## 6-XQ074.01 Ladies Mile HIF Concept Design Report Addendum 1

<b>To</b>	Warren Ladbrook
<b>Copy</b>	Ulrich Glasner, Simon Leary, David Sommerville, Reece Gibson and Richard Hilliard
<b>From</b>	Brandon Ducharme
<b>Office</b>	Queenstown Office
<b>Date</b>	1/06/2018
<b>File</b>	6-XQ074.01 Ladies Mile HIF Concept Design Report 28 05 2018 IFR QS and MBIE Rev B: Addendum 1
<b>Attachment</b>	(1) Appendix D - Three Waters Alignment and Capacity Maps 1 06 2018
<b>Subject</b>	Ladies Mile HIF and all other HIF Project Works– Project Status Update and Budgets

Following the recent review meeting held on 1/06/2018 with Rationale, WSP Opus and the QLDC at the QLDC offices in preparation for submission to MBIE for QS survey and Costing review of the Ladies Mile HIF Concept Design Report 28 05 2018 IFR QS and MBIE, please consider the enclosed provisions as an addendum to the concept design package dated Rev B 28 05 2018.

Figure 1: Summary of Development Areas [REVISED 1/06/2018]

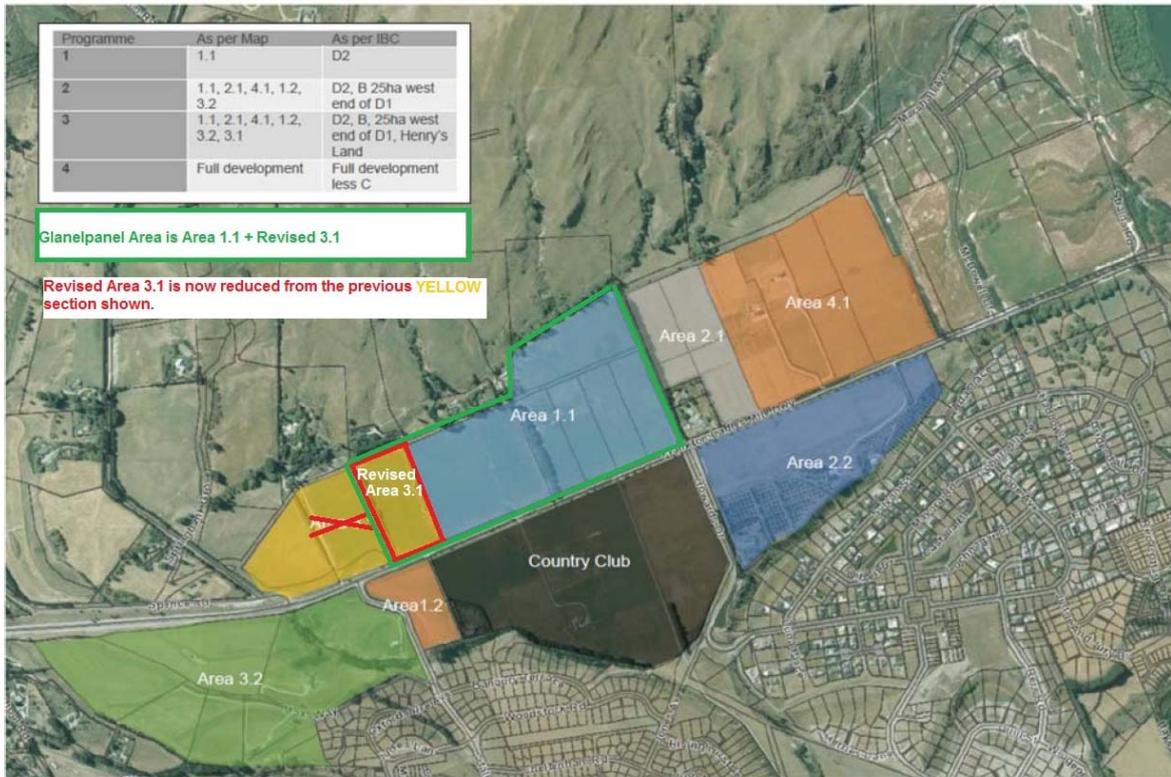
- 3.) Report Page 2, *Figure 1: Summary of Development Areas*, as well as Page 8, *Figure 4: Ladies Mile Development area extents for 3 waters design (shown outlined in red)* have been revised by Rationale to reflect the Glenpanel development within this area, and the revised Area 3.1 extents as Henry’s land is at this time determined to be unlikely to proceed, as advised by Rationale on 1/6/2018. See below:
